## V2500-A1/A5/D5 PROPULSION SYSTEMS SERVICE BULLETIN

This document transmits Revision 4 to Service Bulletin EV2500-72-0401

# V2500-ENG-72-0401

ENGINE – PROVIDE NICKEL PLATING ON THE NUMBER 4 CARBON SEAL HOUSING PILOT DIAMETER

Engine - No.4 bearing front seal assembly  
Fig 1

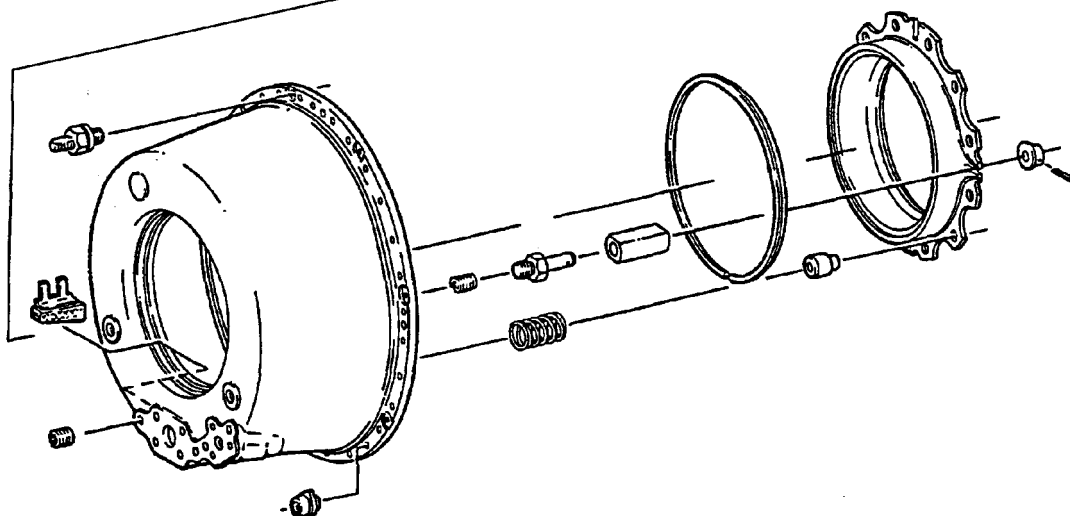
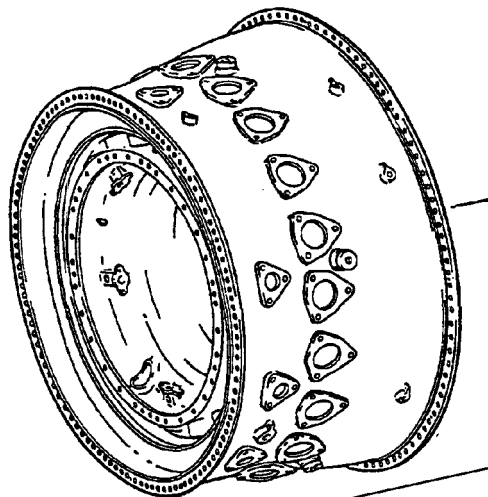
- (2) For V2500-A1/A5 Engines.
  - (a) Replace the No. 4 Bearing Support Assembly, PN 2A2833 with 2A3537.
    - (i) When you assemble the No. 4 Bearing Front Seal Assembly, PN 2A3538 or 2A3581 install the No. 4 Bearing Seal Support Assembly PN 2A3537 (1 off) by the procedure given in Reference (6), Chapter/Section 72-42-33, Assembly. Refer to Figure 1.

Engine - No.4 bearing rear seal assembly  
Fig 2

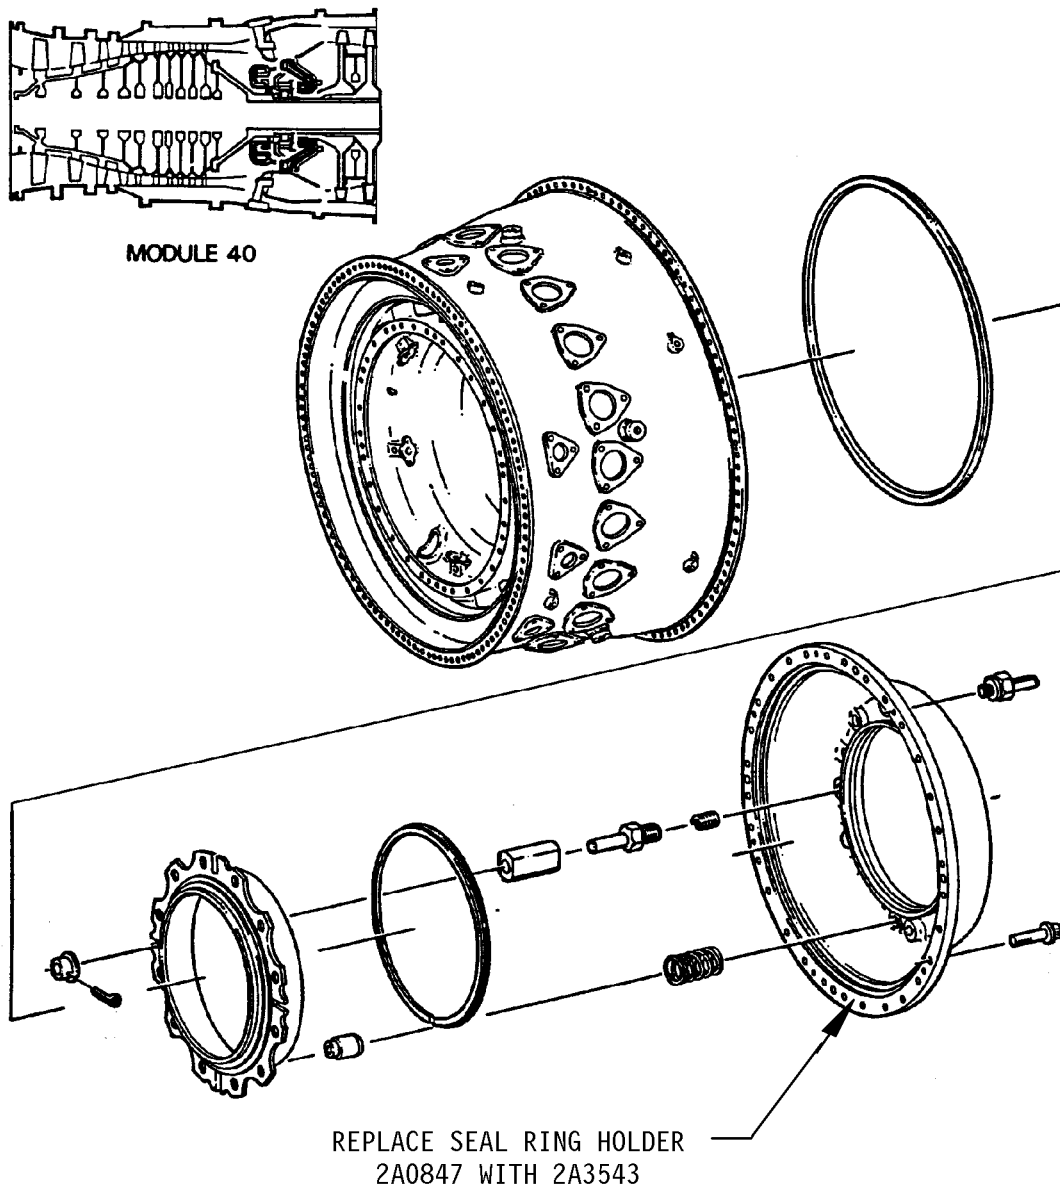
- (b) Replace the No. 4 Bearing Rear Seal Assembly, PN 2A2931 or 2A3526 with 2A3582 or 2A3544 respectively.
    - (i) When you assemble the No. 4 Bearing Rear Seal Assembly, install the 2A3543 No. 4 Bearing Seal Ring Holder (1 off) by the procedure given in Reference (6), Chapter/Section 72-42-33, Assembly. Refer to Figure 2.

Family tree – No.4 bearing front seal assembly and No.4 bearing seal support  
assembly Ref. catalog sequence No's 72-42-33 Fig 1 item 001 and 020

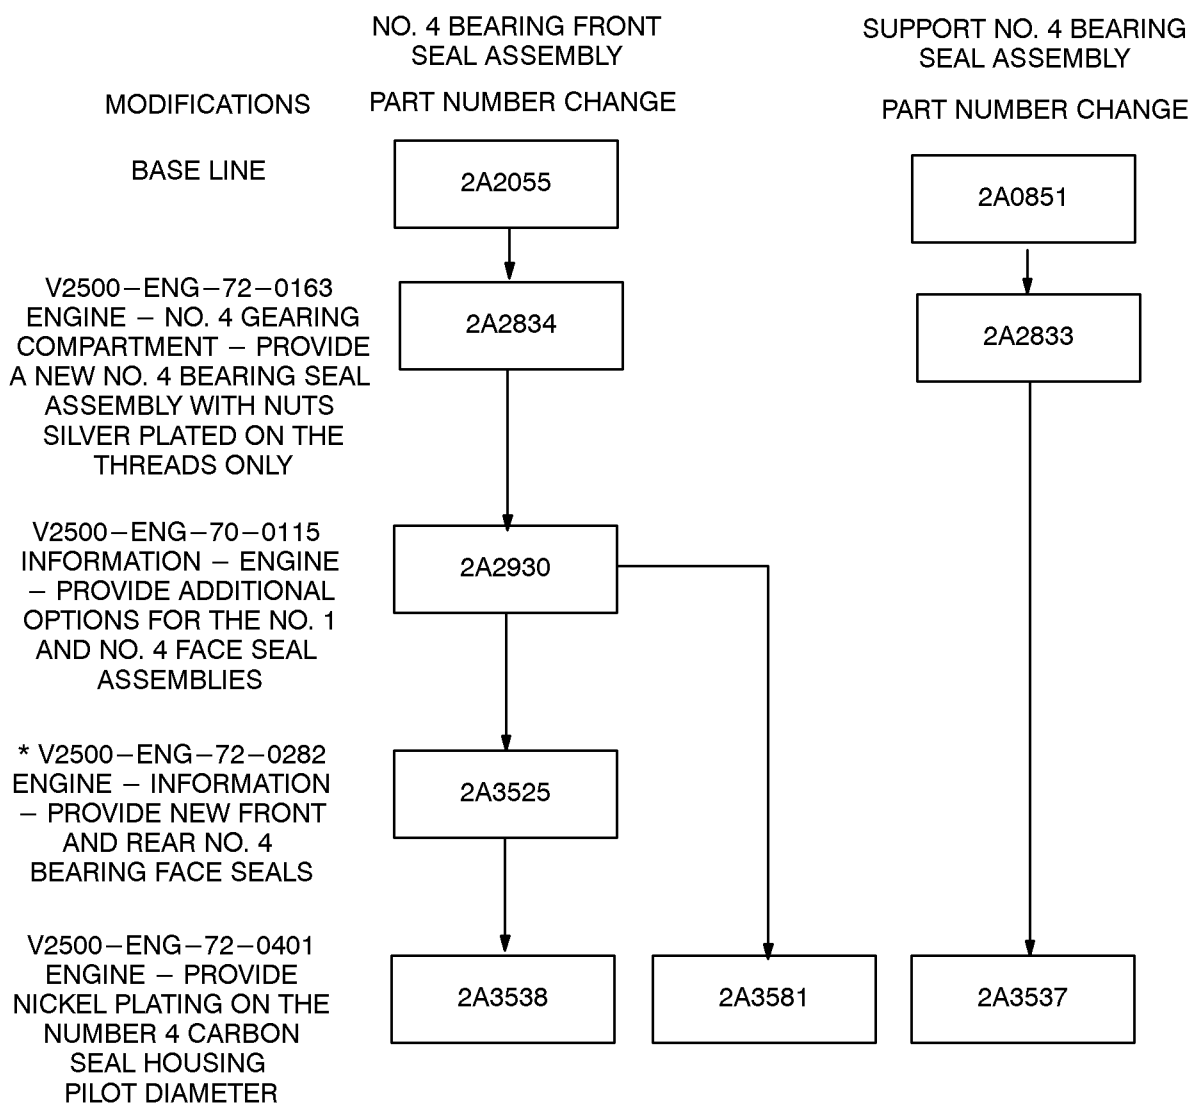
Figs 3 and 4 – Parts Progression to Show the Changed Part in Relation to Other Parts
